**[Docket No. FAA-2021-0872; Project Identifier MCAI-2021-00312-R]**

#### **Airworthiness Directives; Airbus Helicopters**

**ACTION:** Notice of proposed rulemaking (NPRM).

**Figure 2 to paragraph (g)(1)(ii) – Inspection Areas of Tail Rotor Splined Flange**

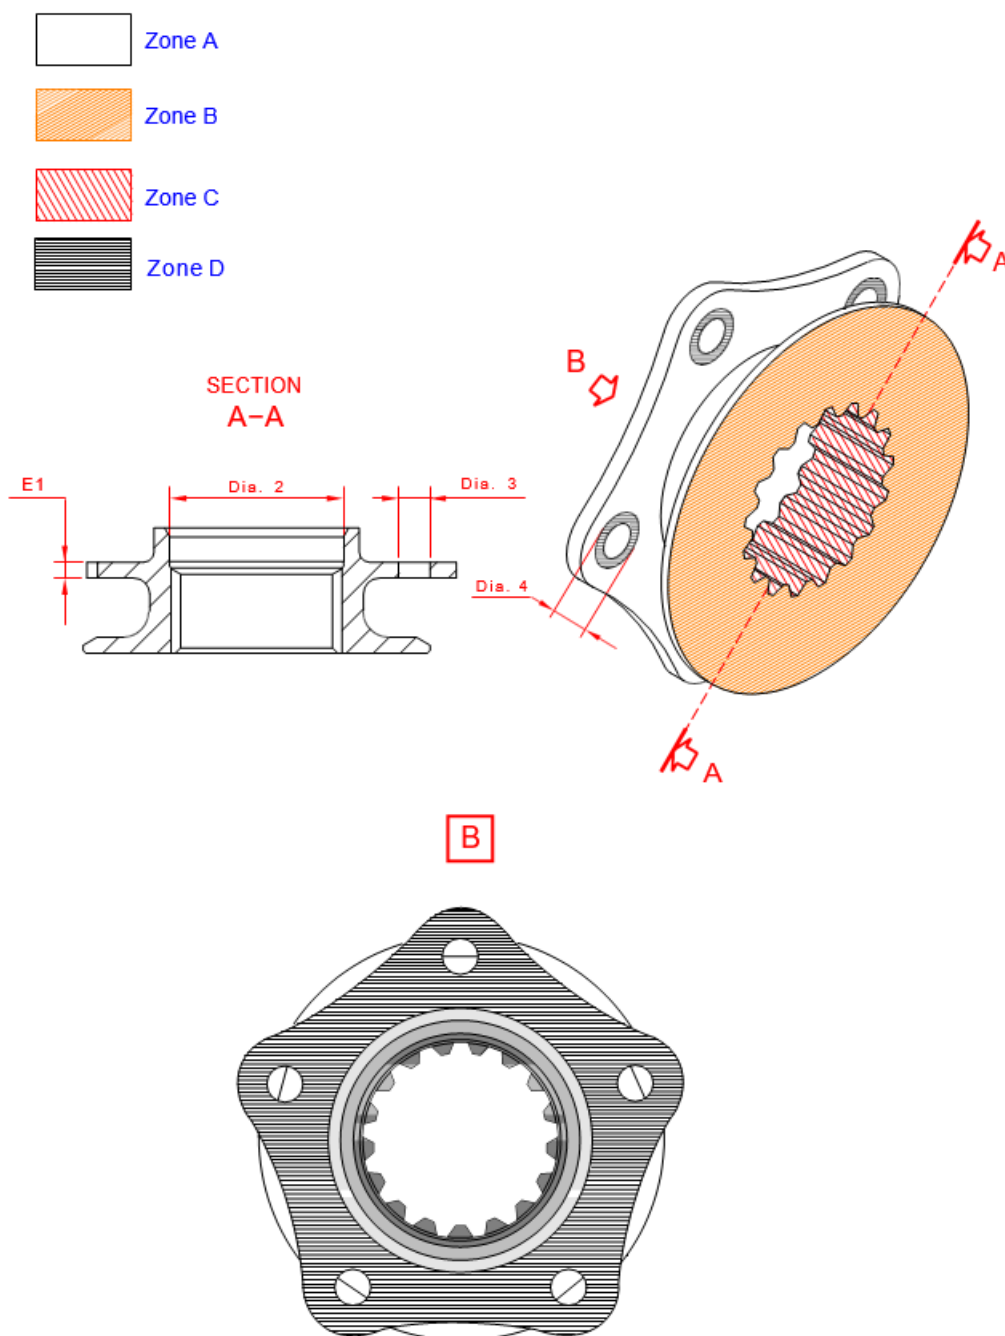
(ii) Inspect the TR splined flange for corrosion, impacts, fretting, wear, and a crack in the areas identified in Figure 2 of this AD. If the condition of the part (including corrosion, impacts, fretting, wear, or cracks) exceeds the criteria as specified in Figure 1 of this AD, before further flight, remove the splined flange from service and replace with an airworthy part.

<i>Flange</i>	
<b>Location as specified in figure 2 to paragraph (g)(1)(ii) of this AD</b>	<b>Maximum damage, which causes replacement (E1, Dia. 2, Dia. 3, and Dia. 4 are shown in figure 2 to paragraph (g)(1)(ii) of this AD)</b>
Zone A	Scratch depth > 0.2 mm (0.008 in.). Crack. E1 < 2.75 mm (0.108 in.). Dia. 3 > 6.02 mm (0.2371 in.). Dia. 2 > 33.03 mm (1.3004 in.).
Zone B	Touch-up depth > 0.1 mm (0.004 in.). Crack.
Zone C	Crack. Scratch depth > 0.2 mm (0.008 in.).

Location as specified in figure 2 to paragraph (g)(1)(ii) of this AD	Maximum damage, which causes replacement (E1, Dia. 2, Dia. 3, and Dia. 4 are shown in figure 2 to paragraph (g)(1)(ii) of this AD)
Zone D [Dia. 4 = 14 mm +/- 0.1 mm (0.548; 0.555in.)]	Touch-up depth > 0.1 mm (0.004 in.). Crack. E1 < 2.75 mm (0.108 in.).
